PREPARED	NAME L. Pazmany	8-12-69	PAZMANY AIRCRAFT CORPORATION — SAN DIEGO — CALIFORNIA —	MODEL NO.	P-1
CHECKED			ENGINEERING CHANGE NOTICE #8	REPORT NO.	
APPROVED				PAGE NO.	1

PREPARED	NAME L. Pazmany	8-12-69	PAZMANY AIRCRAFT CORPORATION — SAN DIEGO — CALIFORNIA —	MODEL NO.	PL-1
CHECKED			ENGINEERING CHANGE NOTICE # 8	REPORT NO.	
APPROVED				PAGE NO.	2

DWG 1-20-003 - STABILATOR

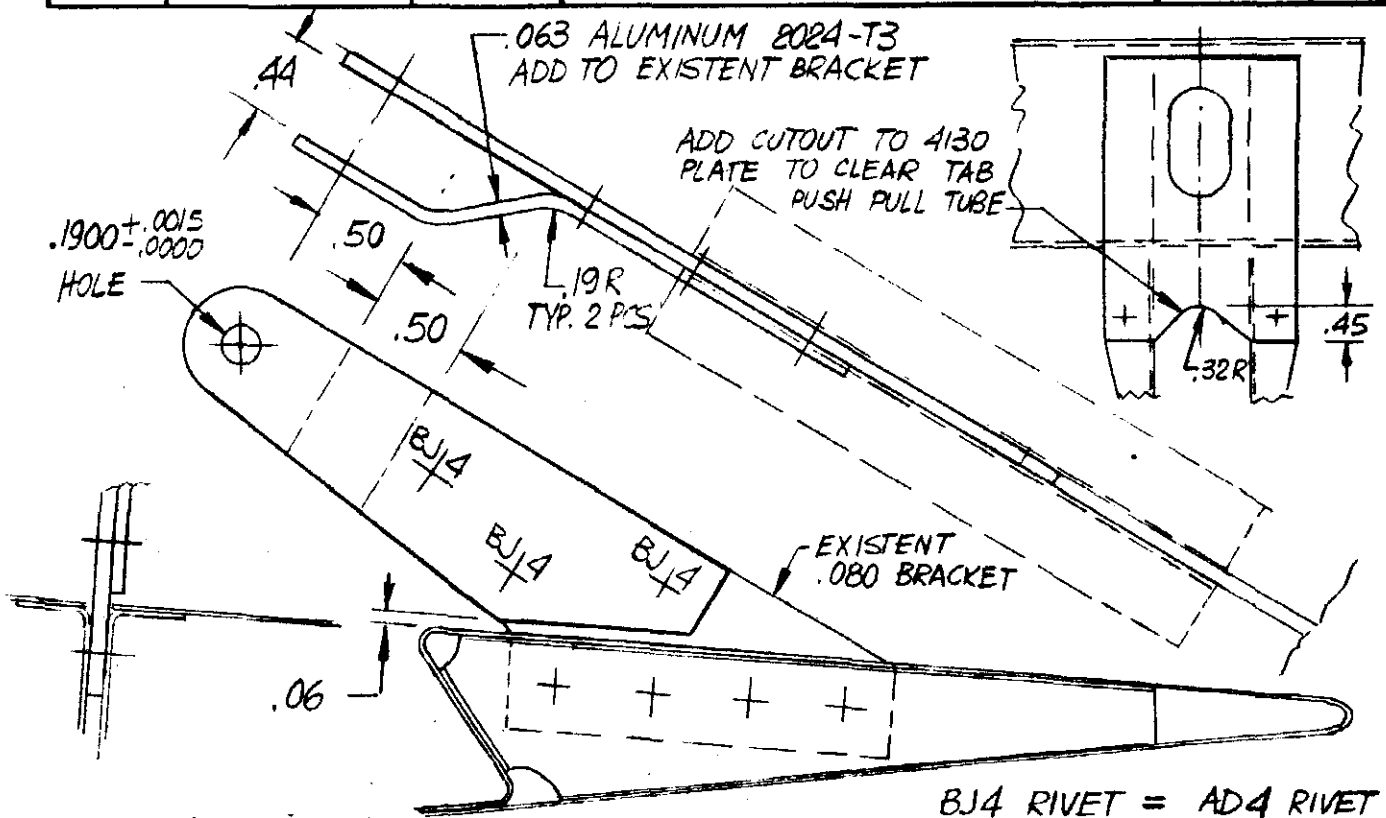
THE ADDITIONAL BRACKET FOR THE STABILATOR TAB SHOWN IN PAGE 1 OF THIS ECN IS A "FAIL-SAFE" DESIGN. WITH SO MUCH PUBLICITY GIVEN TO FLUTTER PROBLEMS IN STABILATORS USED IN SOME OTHER DESIGNS I WOULD LIKE TO SEE THIS SAFETY MEASURE IN ALL PL-1 AIRPLANES. FORTUNATELY THE PL-1 FLYING, SO FAR DID NOT SHOW ANY SIGN OF FLUTTER. THE MAXIMUM SPEED SHOULD NEVER EXCEED 175 MPH. THE STRUCTURE WAS STRESSED TO A HIGHER SPEED, BUT ONLY TESTED TO 175 MPH.

DWG 1-20-003 - STABILATOR

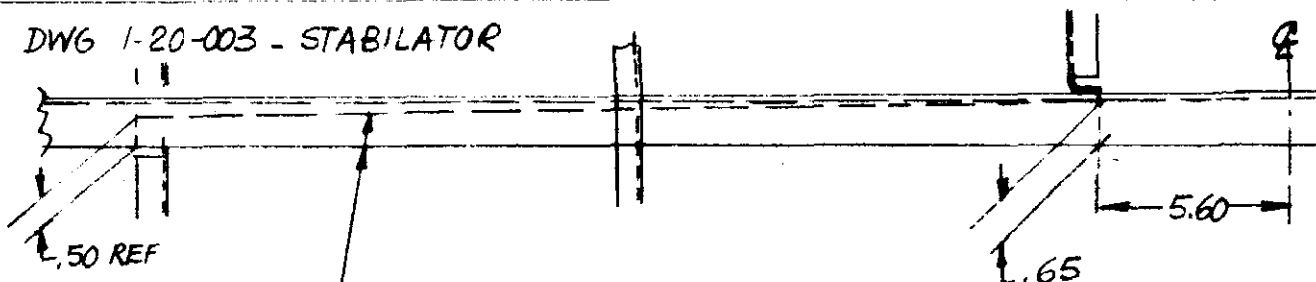
WIDTH OF STRAP TAPERS FROM .50 AT END TO .65 AT INBD RIB
